ADDENDUM # 02

Project: Mt Diablo Unified School District
Rio Vista Elementary, Mt Diablo Elementary & Meadow Homes Elementary
Acoustic Ceiling Tiles and Shade Coverings
19six #: 23118, 23119, & 23120

Bid #: 1962
Date: August 27, 2025

SHEET TITLE
BLDG 2, 5, & 7 - WINDOW ROLLER SHADE FLOOR PLAN

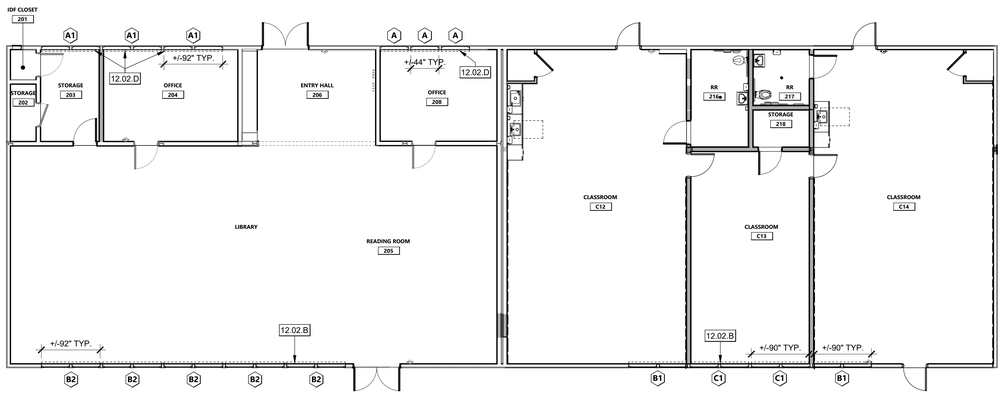
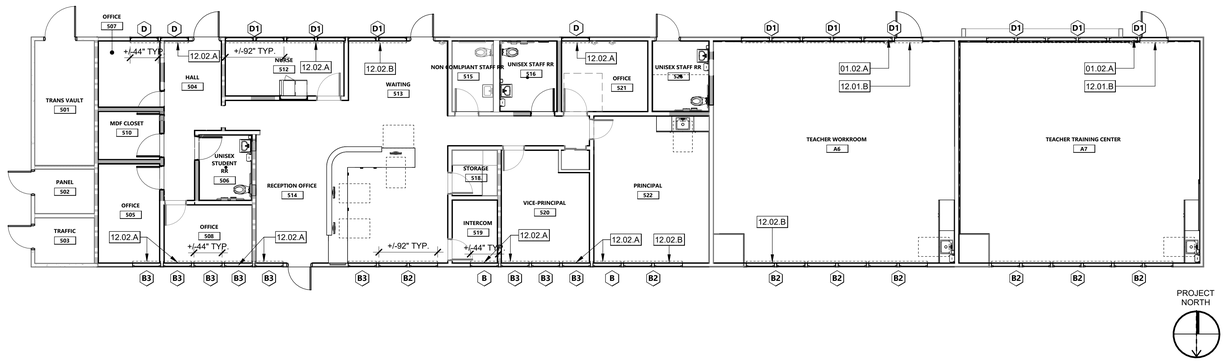
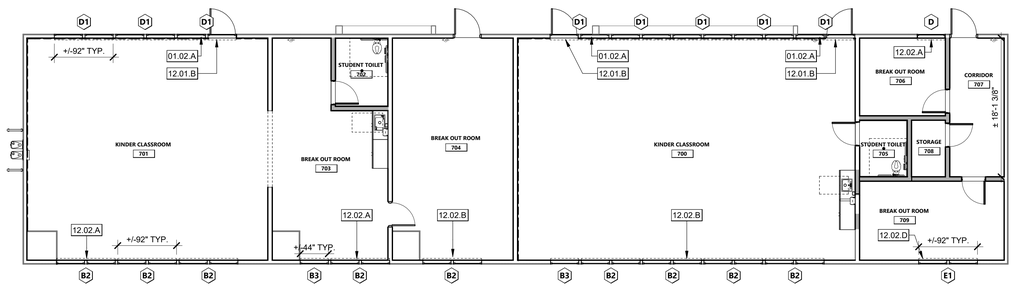
Item #2: **A-201 BLDG 2, 5, & 7 – WINDOW ROLLER SHADE FLOOR PLAN** Updates to the keynotes to reference the correct sheet and detail number. Update of some shades to Dual Bracket System. Added interior elevation 5

BLDG 3,4,6,8,9,10,11 & 12 - FLOOR PLAN - ROLLER SHADES

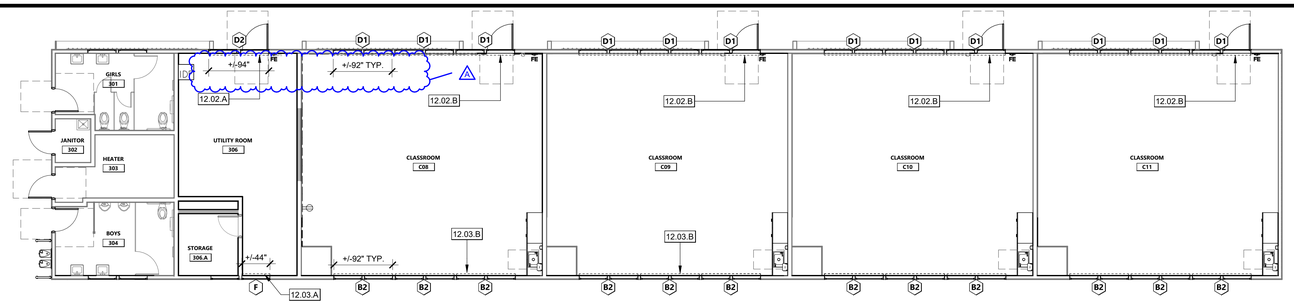
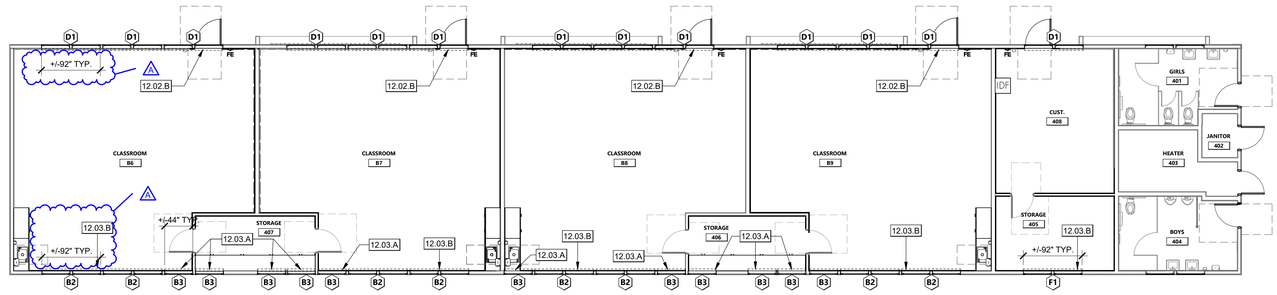
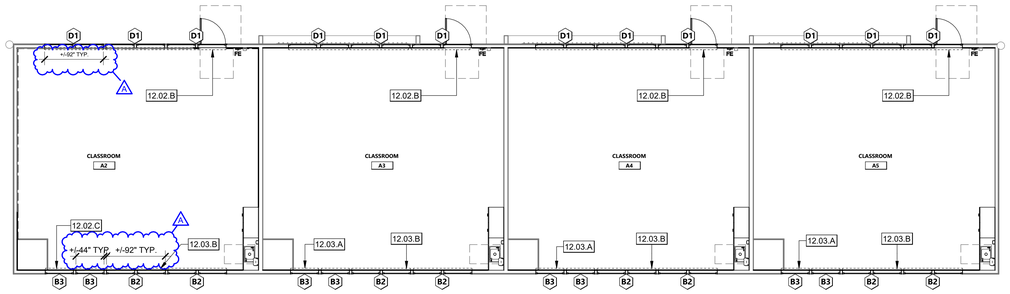
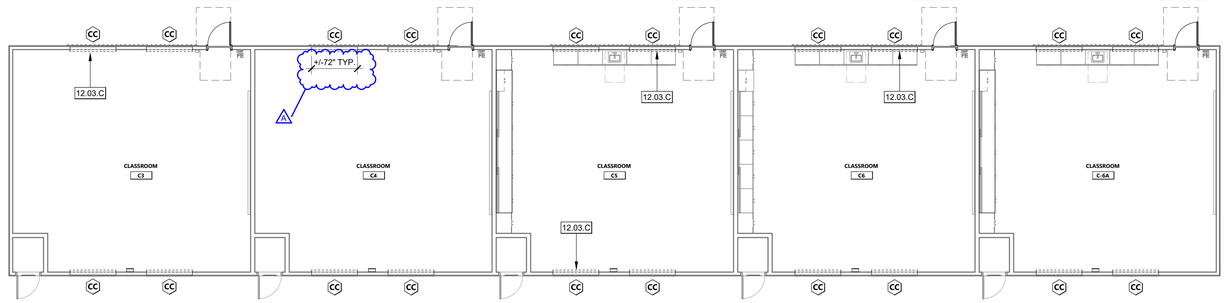
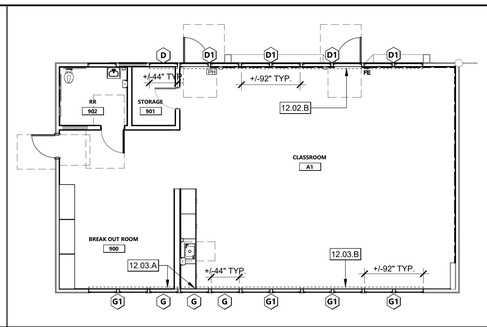
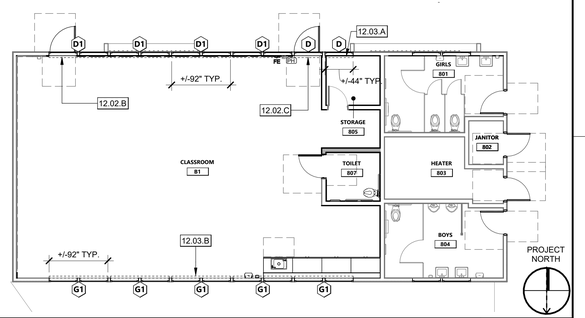
Item #3: **A-202 BLDG 3, 4, 6, 8, 9, 10, 11, & 12 – FLOOR PLAN ROLLER SHADES** Updates to the keynotes to reference the correct sheet and detail number. Added dimensions

BLDG 3 & 4 - REFLECTED CEILING PLAN

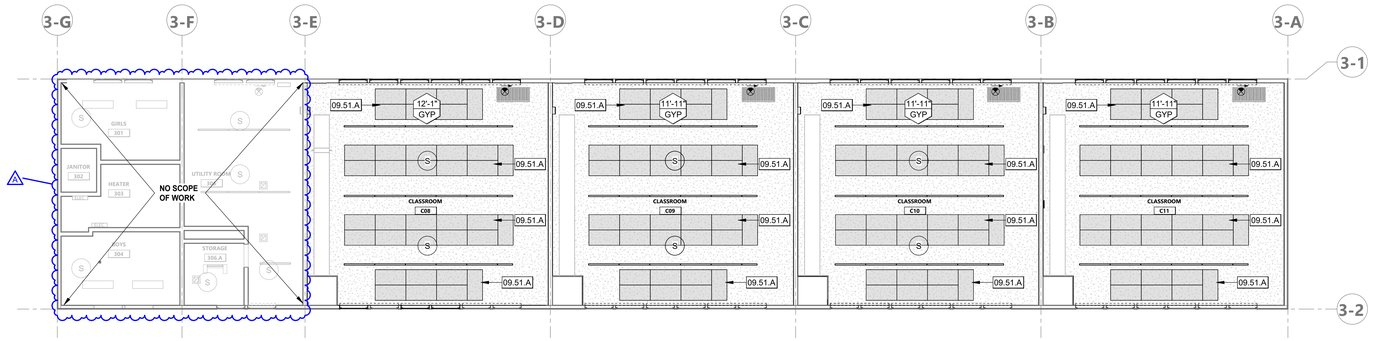
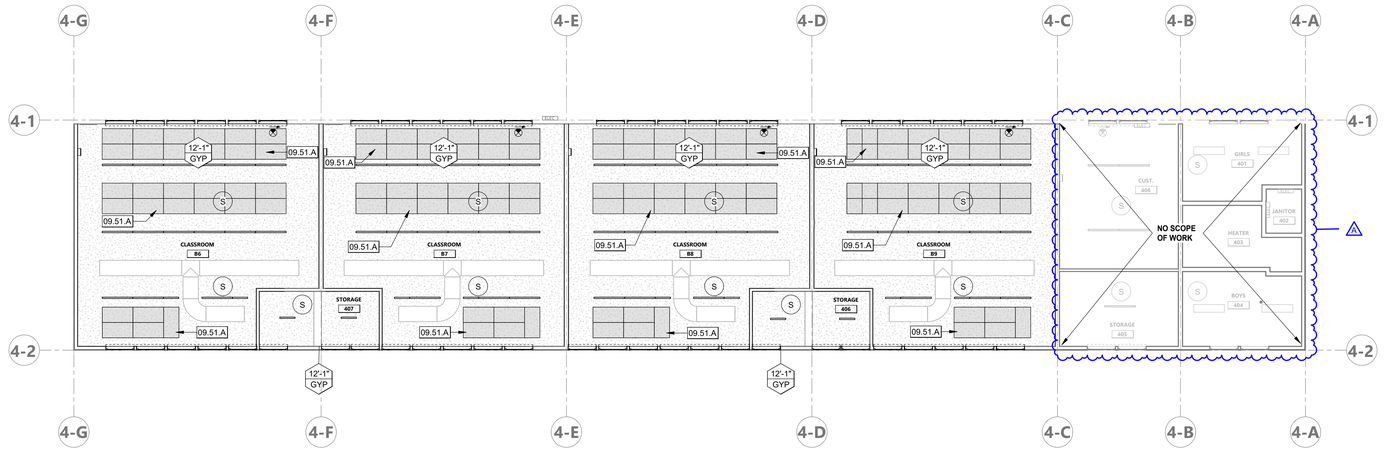
Item #5: **A-211 BLDG 3 & 4 REFLECTED CEILING PLAN** Edited keynote 09.51.A, changed/clarified the ceiling general notes, edited the LEGEND – CEILING to clarify existing ceiling items, and clarified areas of no scope. Changed orientation of the ceiling tiles.

BLDG 6, 8 & 9 - REFLECTED CEILING PLAN

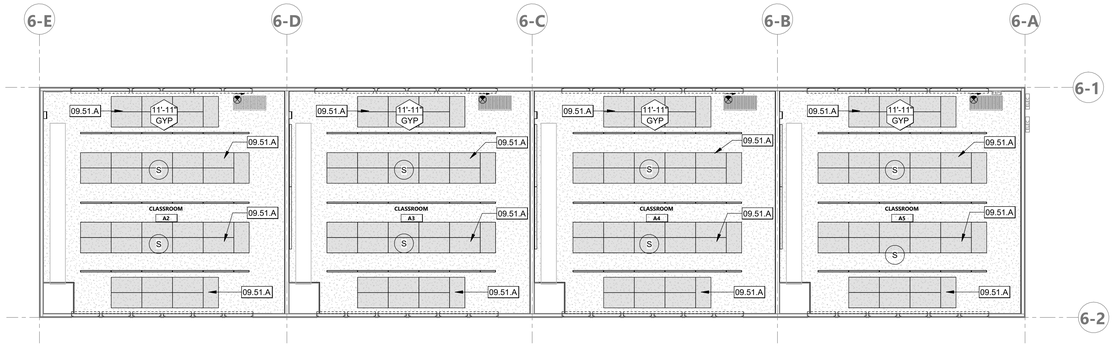
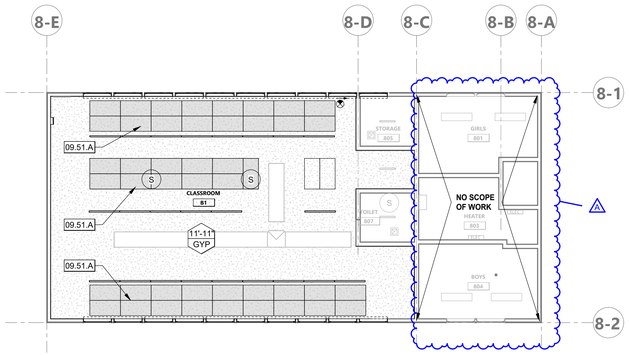
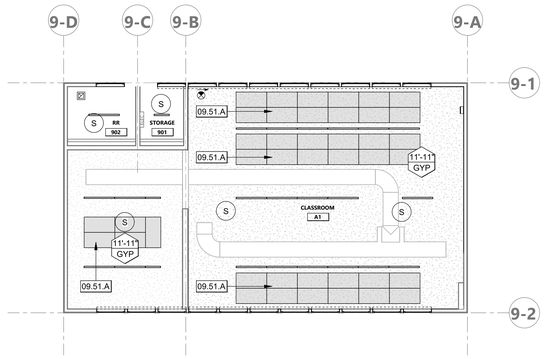
Item #6: **A-212 BLDG 6, 8 & 9 REFLECTED CEILING PLAN** Edited keynote 09.51.A, changed/clarified the ceiling general notes, edited the LEGEND – CEILING to clarify existing ceiling items, and clarified areas of no scope. Changed orientation of the ceiling tiles.

BUILDING K FLOOR PLAN | 1/8" = 1'-0" | 7

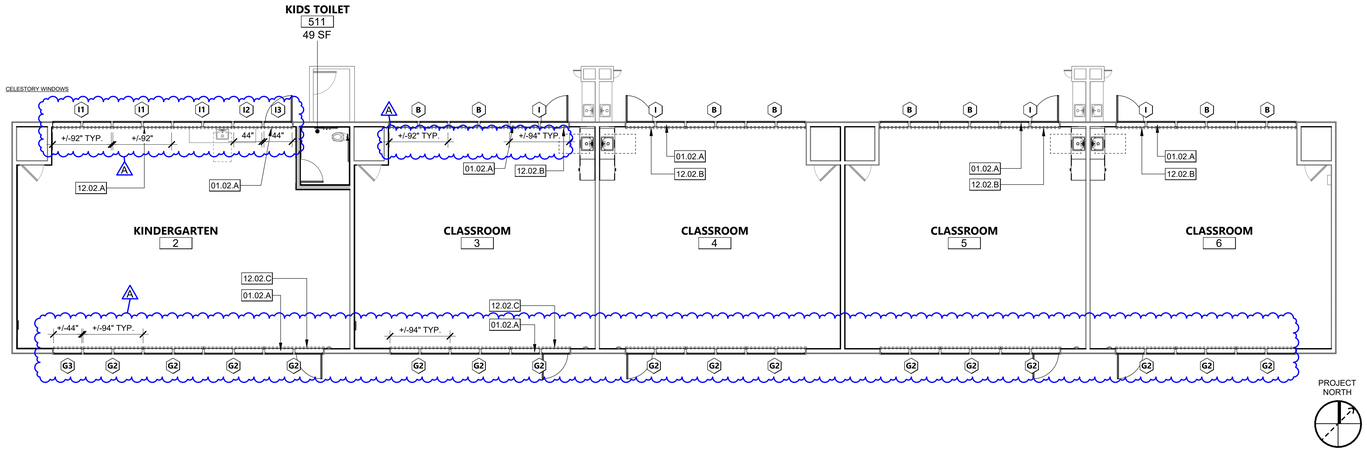
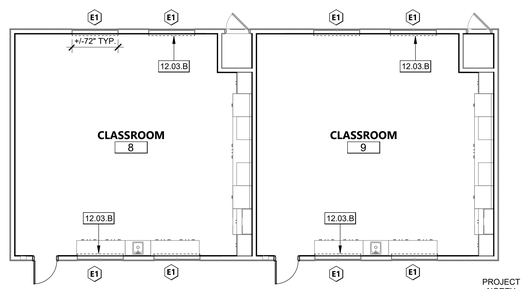
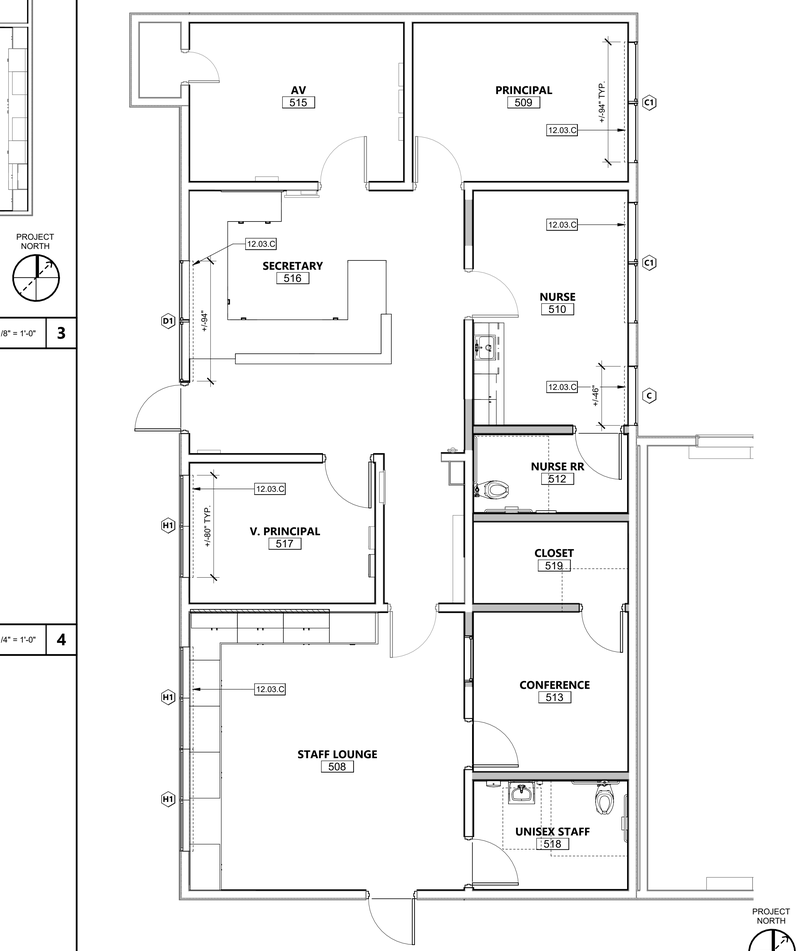
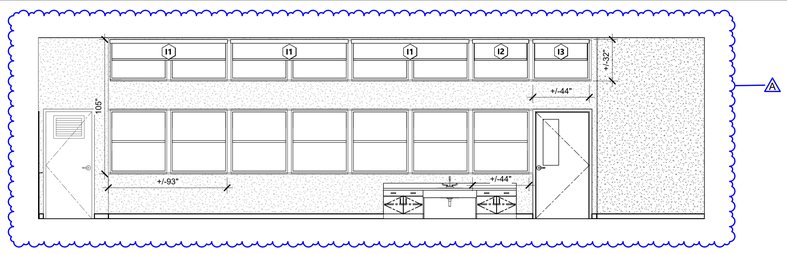
Item #1: **A-201 BLDG K, 1, 5 & 8 – WINDOW ROLLER SHADE FLOOR PLAN** Added typical dimensions at Kindergarten 1, Kindergarten 2, and Classroom 3. Updated the keynote detail call outs. Added roller shade tags to the south of building 1. Updated Elevation 4 with new roller shade heights.

BUILDING 2 FLOOR PLAN - RS | 1/8" = 1'-0" | 1

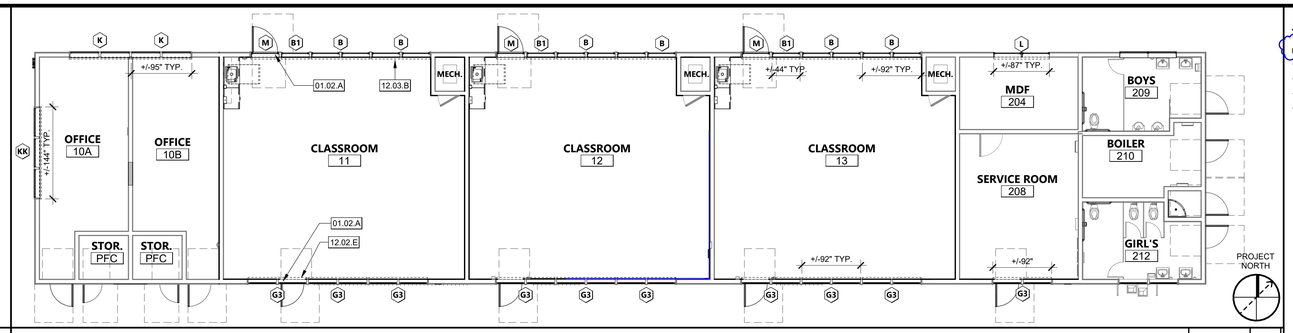
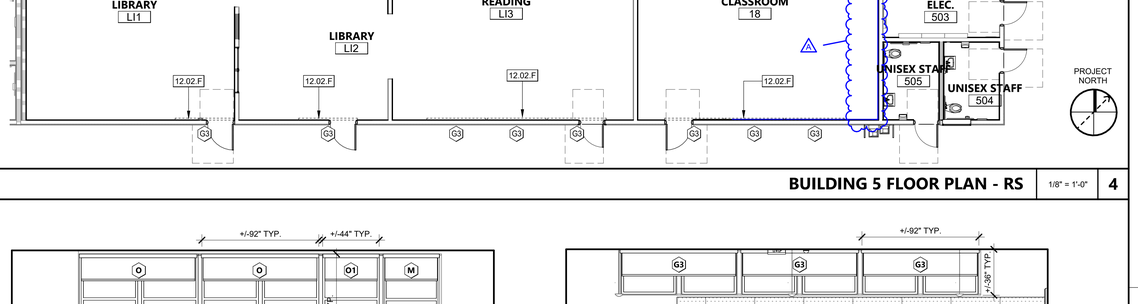
Item #2: **A-202 BLDG 2, 3, 4 & 5 – FLOOR PLANS RS** Added typical dimensions windows, updated keynote 01.02.A, and updated the detail references in keynotes 12.03.A & 12.03.B.

BUILDING 6 FLOOR PLAN RS | 1/8" = 1'-0" | 1

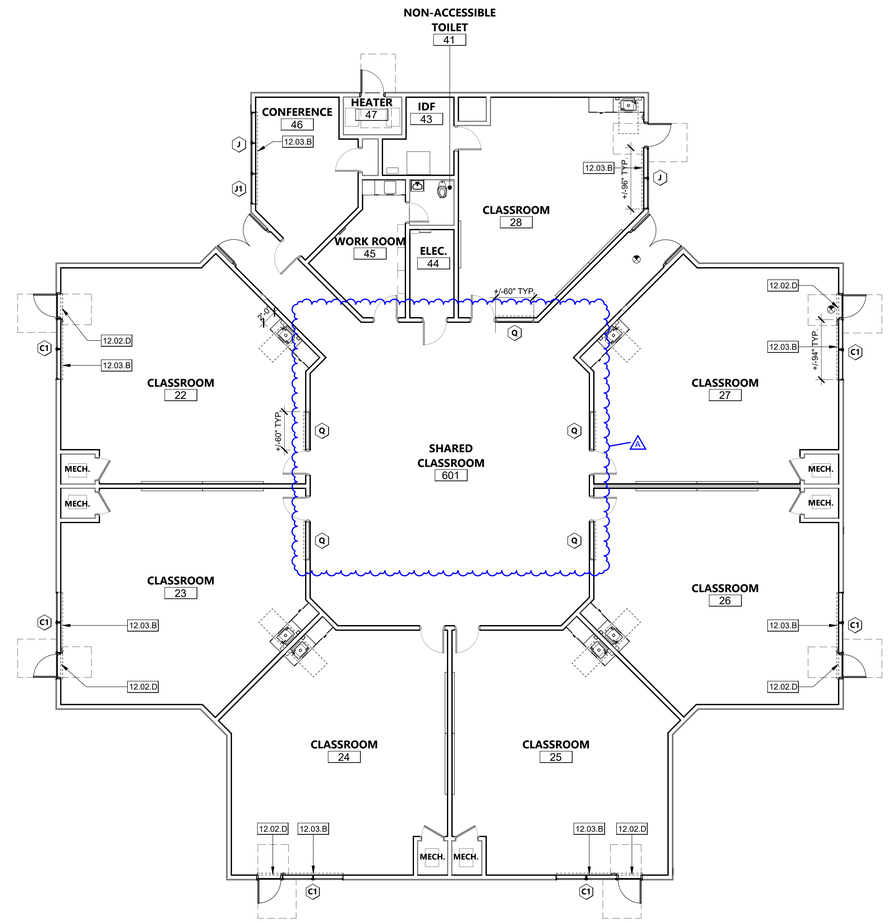
Item #3: **A-203 BLDG 6 - FLOOR PLAN RS** Updated interior window shades at the shared classroom, added elevations 2, 3, 4, 5, & 10

BUILDING 9 FLOOR PLAN - RS | 1/8" = 1'-0" | **1**

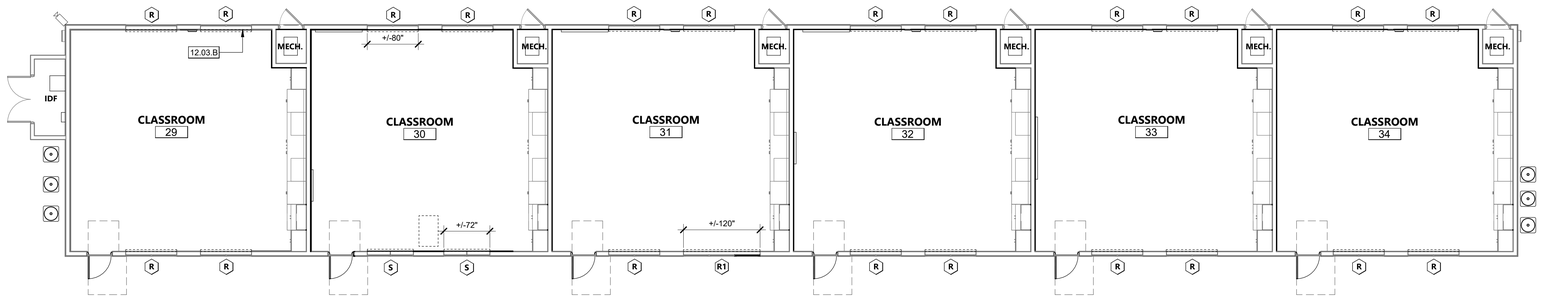
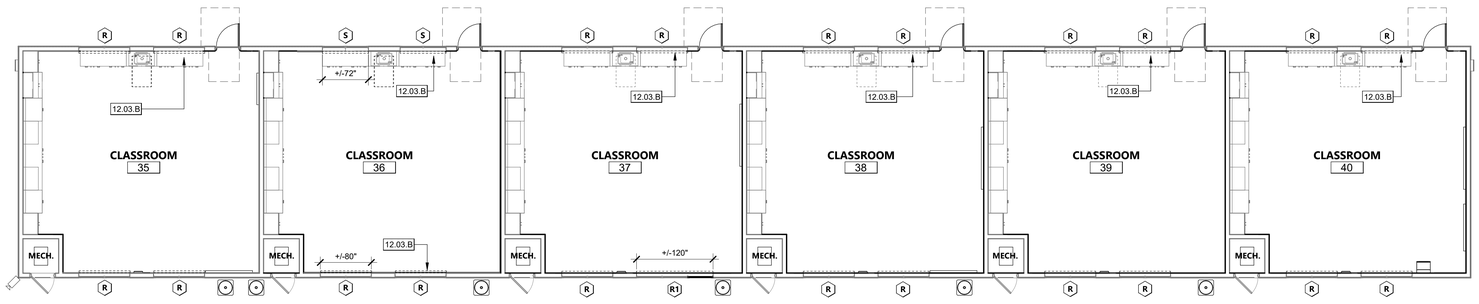
Item #4: **A-204 BLDG 9 & 10 - FLOOR PLANS RS** Added sheet to include buildings 9 & 10 in the scope of work.

BUILDING 2 REFLECTED CEILING PLAN | 1/8" = 1'-0" | 1

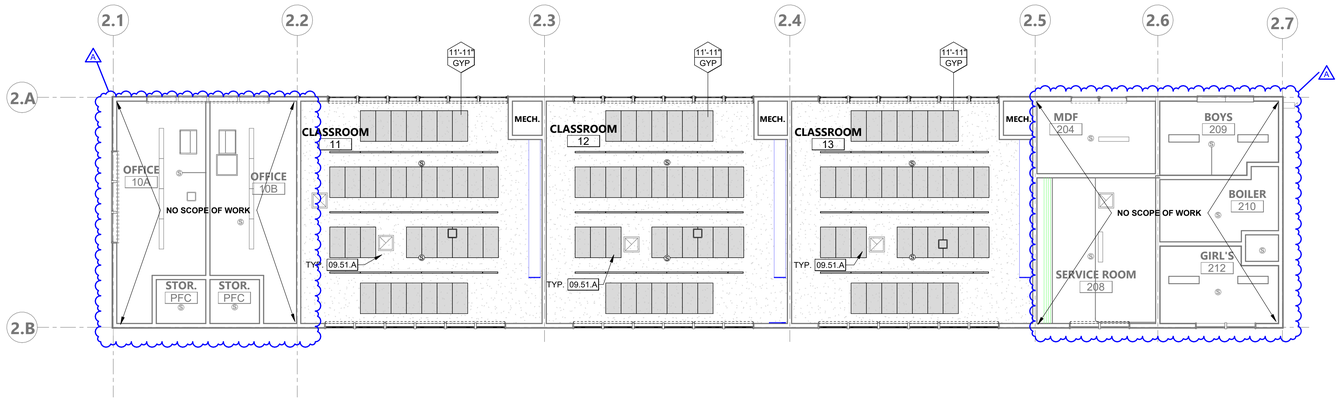
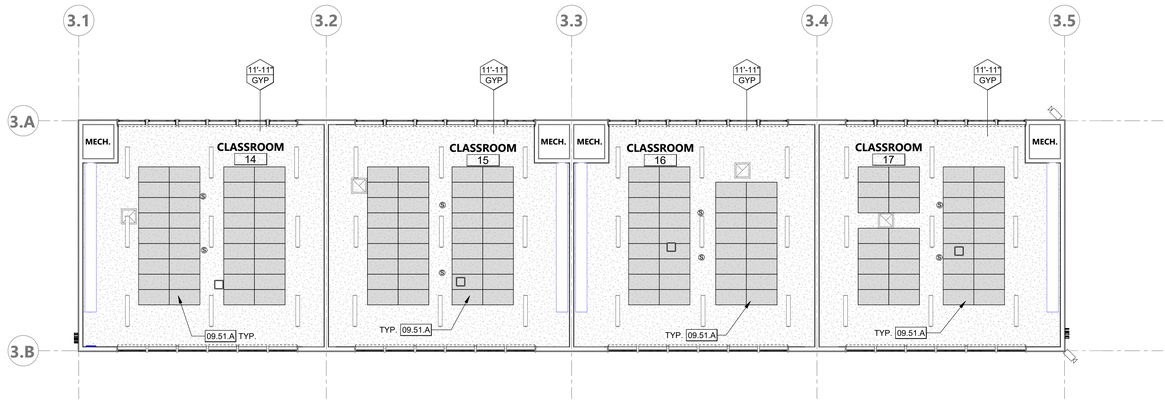
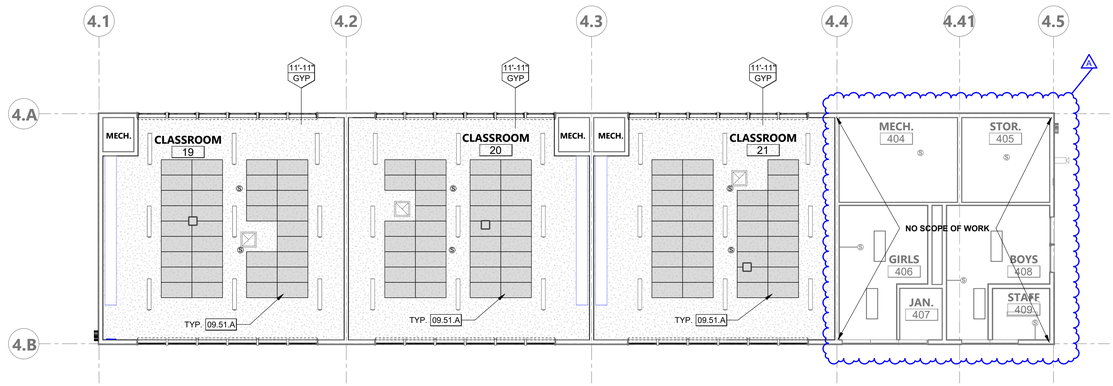
Item #5: **A-205 BLDG 2, 3 & 4 REFLECTED CEILING PLANS** Edited keynote 09.51.A, changed/clarified the ceiling general notes, edited the LEGEND – CEILING to clarify existing ceiling items, and clarified areas of no scope.
